The Secretary  
NSW Department of Planning, Industry and Environment

20 July 2020

I refer to the Department's below email of 18 June 2020 regarding State Significant Development SSD-9063-Mod-1 for the Tallawong Station Precinct at 1-15 & 2-12 Conferta Avenue, Rouse Hill (Lots 293 & 294 DP 1213279) in the Blacktown LGA for Modification to the approved Concept Plan for Tallawong Station Precinct South (SSD 9063) including the following amendments to:

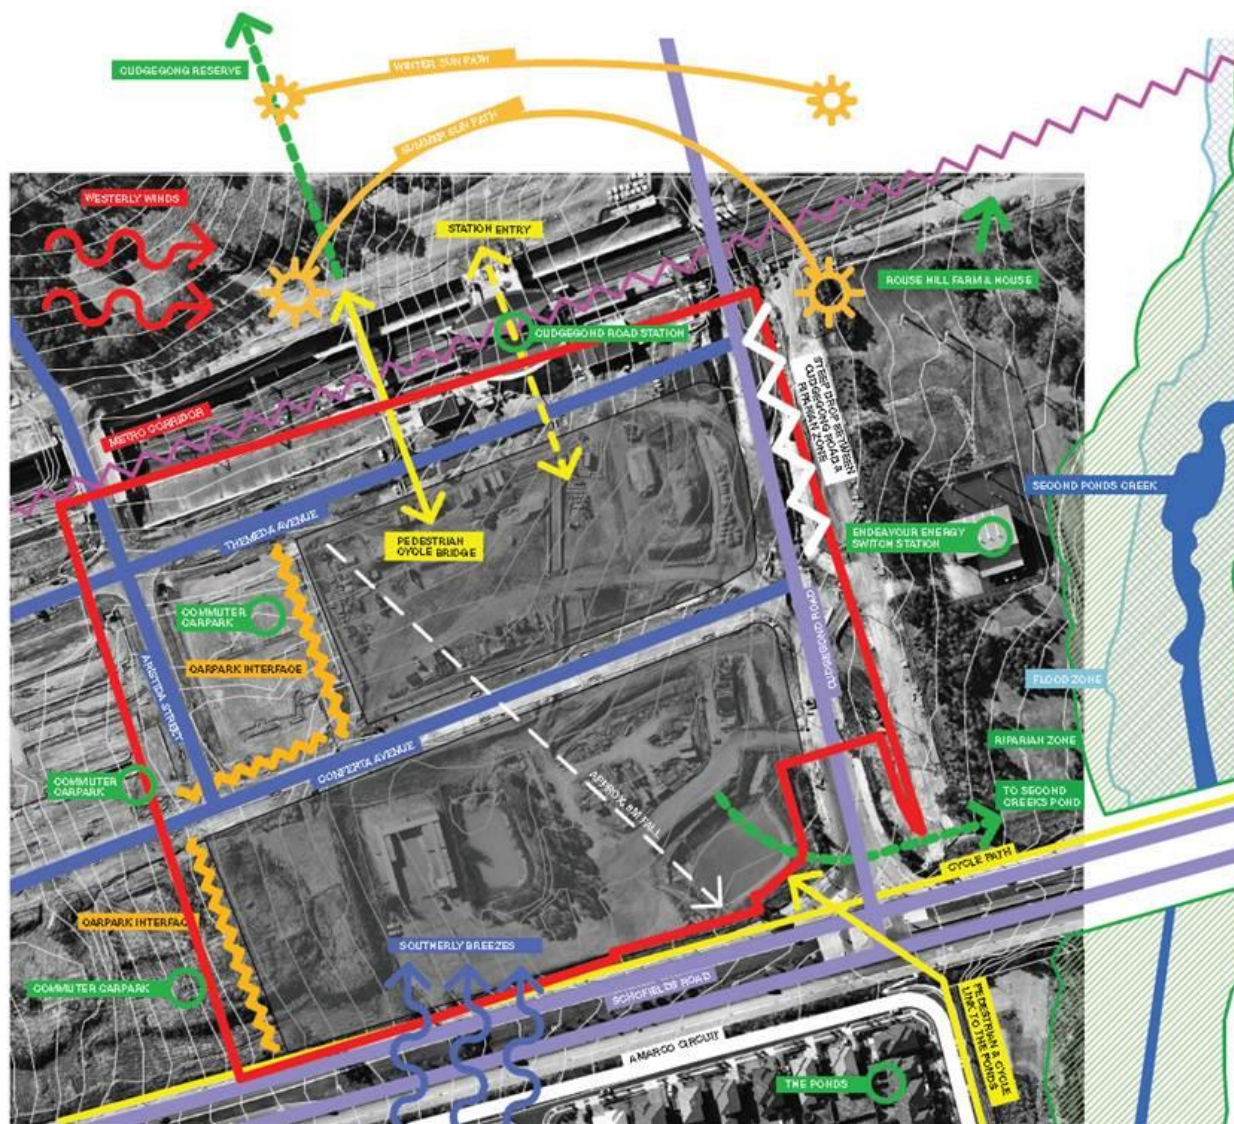
Endeavour Energy has noted that the Environmental Impact Statement does not appear to mention the proximity to Rouse Hill Switching Station or Feeder 9JA. The Urban Design Report as shown in the following extract of the Site Analysis Plan shows 'Endeavour Energy Switch Station' but there appears to be no detail / discussion about a 'complimentary interface' between the Rouse Hill Switching Station / Feeder 9JA and the buildings to the opposite side of Cudgegong Road.

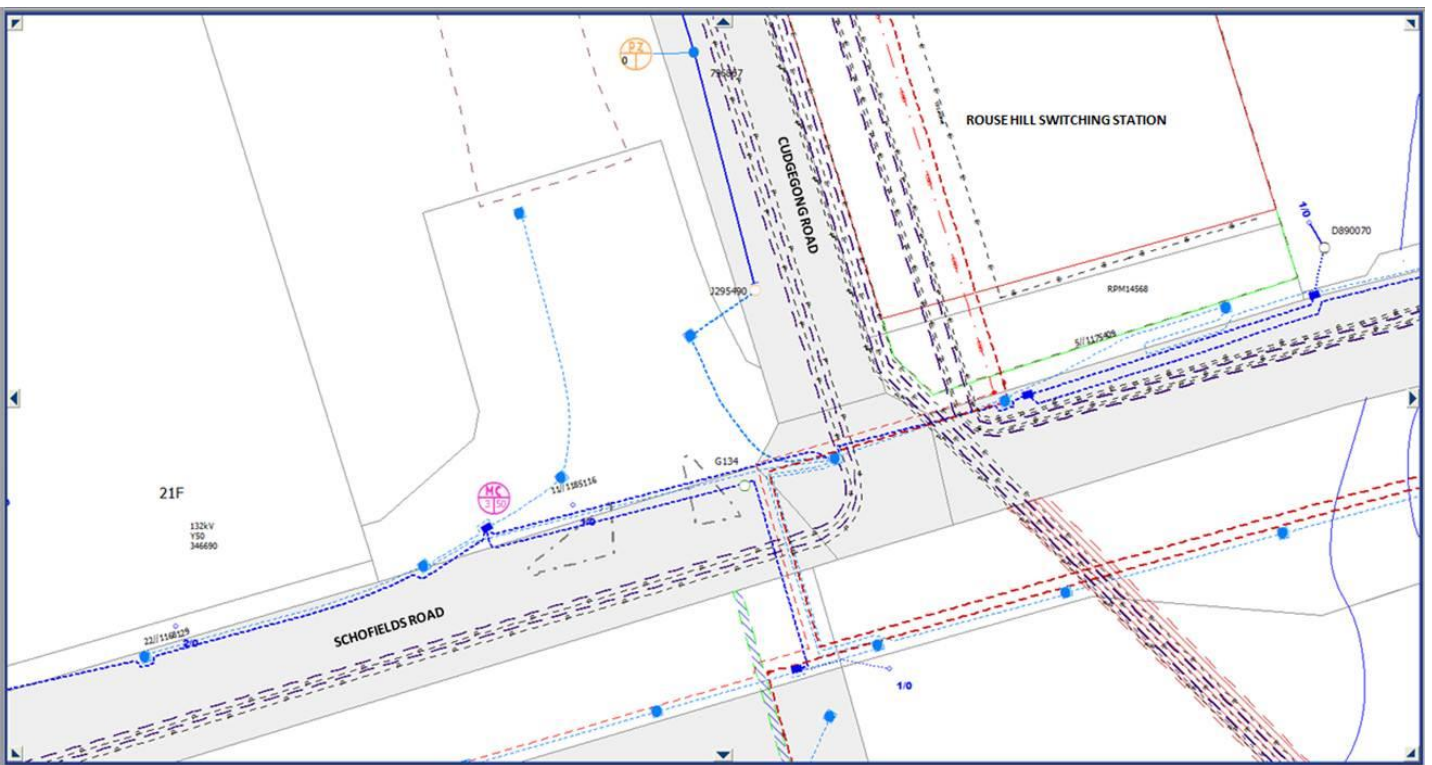
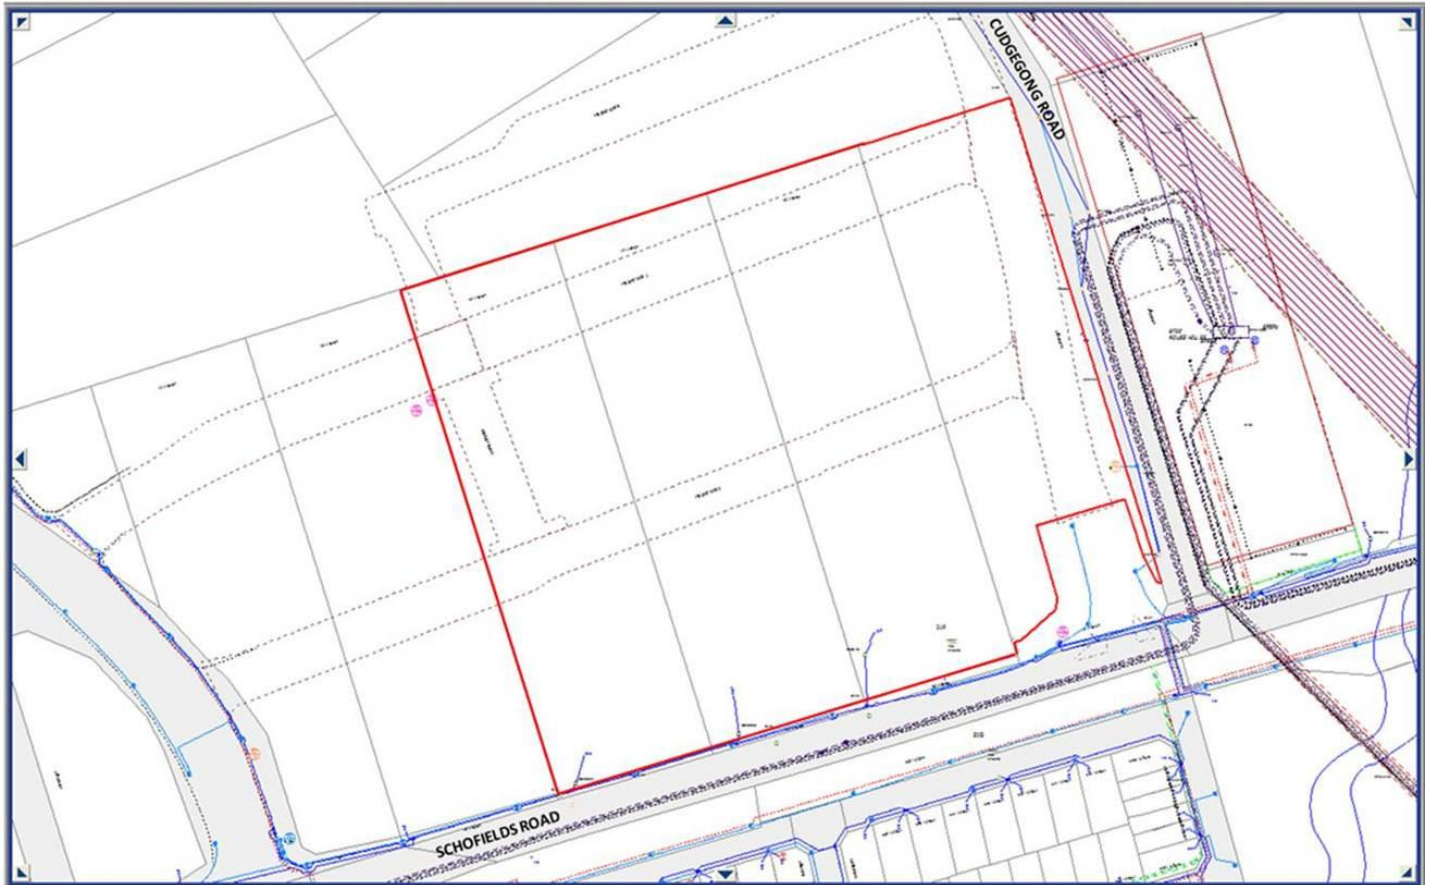
Access to the Rouse Hill Switching Station has previously been affected by the road widening and/or realignment of both Schofields Road (the original site access) and Cudgegong Road. As a result of these previous road works the current access to the site is off Cudgegong Road with a crossing over the original road alignment which is shown in the following extracts of Google Maps Street View.

Access to Rouse Hill Switching Station needs to be maintained at all times. Endeavour Energy will require reasonable notice if any of the road works will affect the access to the site to ensure arrangements are in place to maintain access ie. particularly in the event of an emergency. For safety and security reasons access to the site is restricted. Should access to the site be required by any consultants or contractors, it can only occur with Endeavour Energy's prior consent and under direct supervision.
